## CALIFORNIA COASTAL COMMISSION

#### **STAFF REPORT: APPEAL** **SUBSTANTIAL ISSUE**

**APPEAL NO.:** A-4-CPN-03-016

**PROJECT DESCRIPTION:** Construction of a 2,207 sq. ft. two story single family home with attached garage/workshop, porch, driveway, fence, garden wall, sidewalk, drainage structures, vegetated bio-swale, restoration of riparian habitat, and 464 cu. yds. of grading (308 cu. yds. cut, 156 cu. yds. fill).

ESTIMATED VIEW BLOCKAGE FROM THREE PUBLIC AREAS BY  
FILLING IN AREAS STAKED BY ARCHITECT

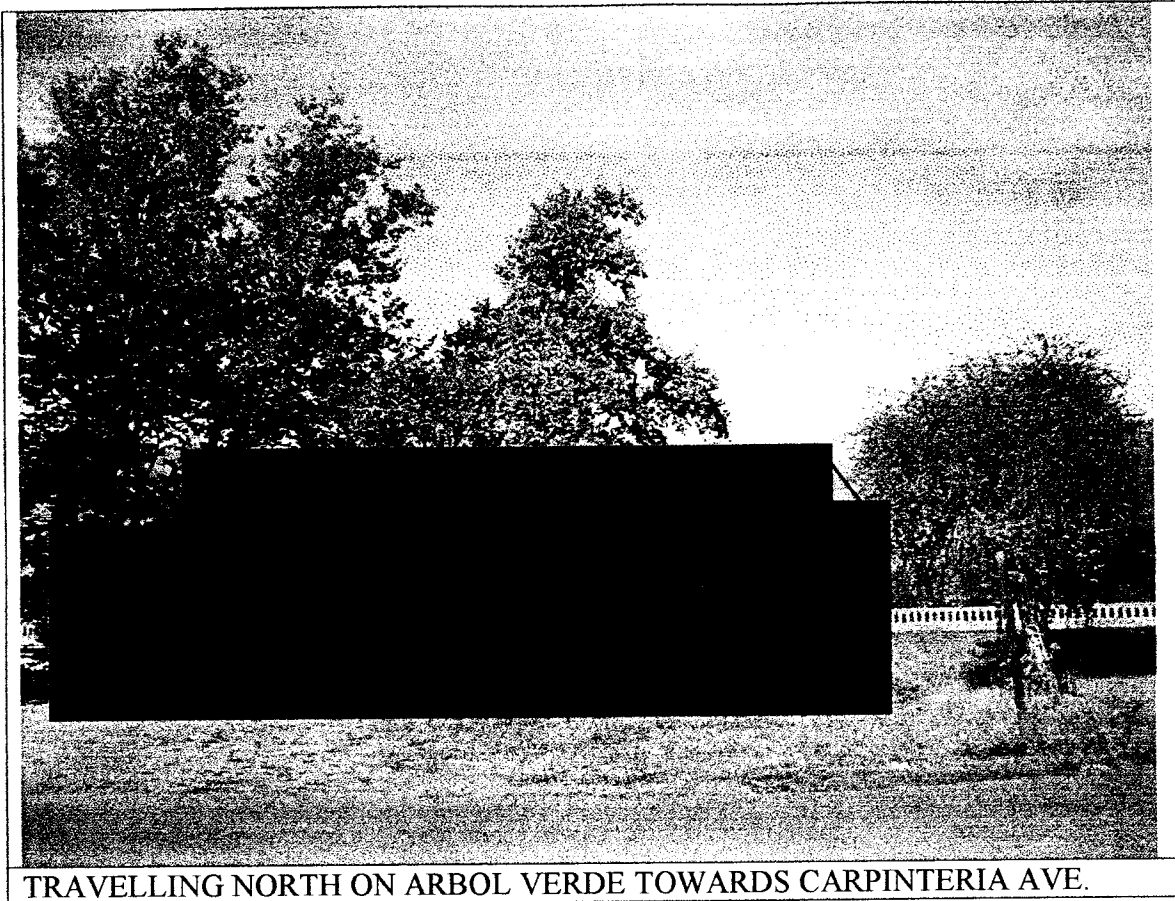
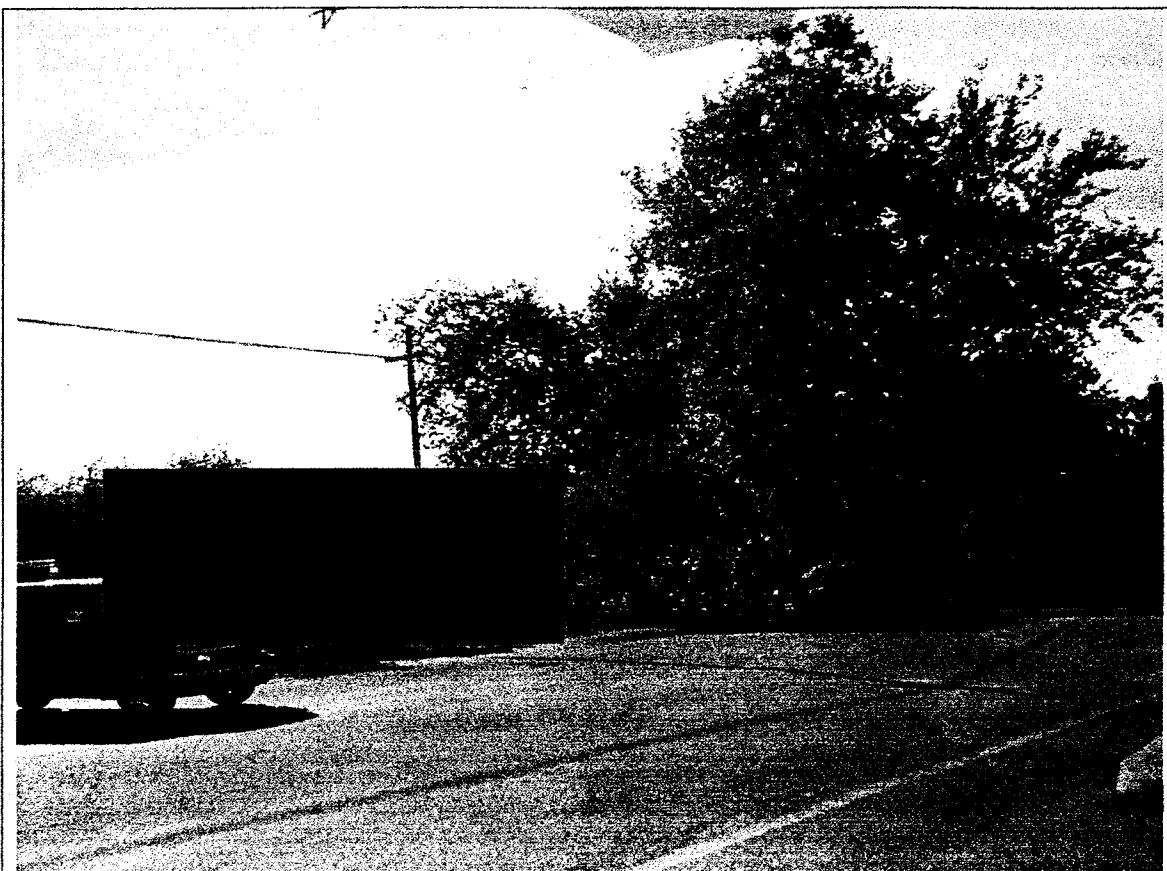
TRAVELLING NORTH ON ARBOL VERDE TOWARDS CARPINTERIA AVE.

LOOKING NORTH WHILE TRAVELLING EAST ON CONCHA LOMA TOWARDS  
ARBOL VERDE

TRAVELLING WEST ON CARPINTERIA AVE.
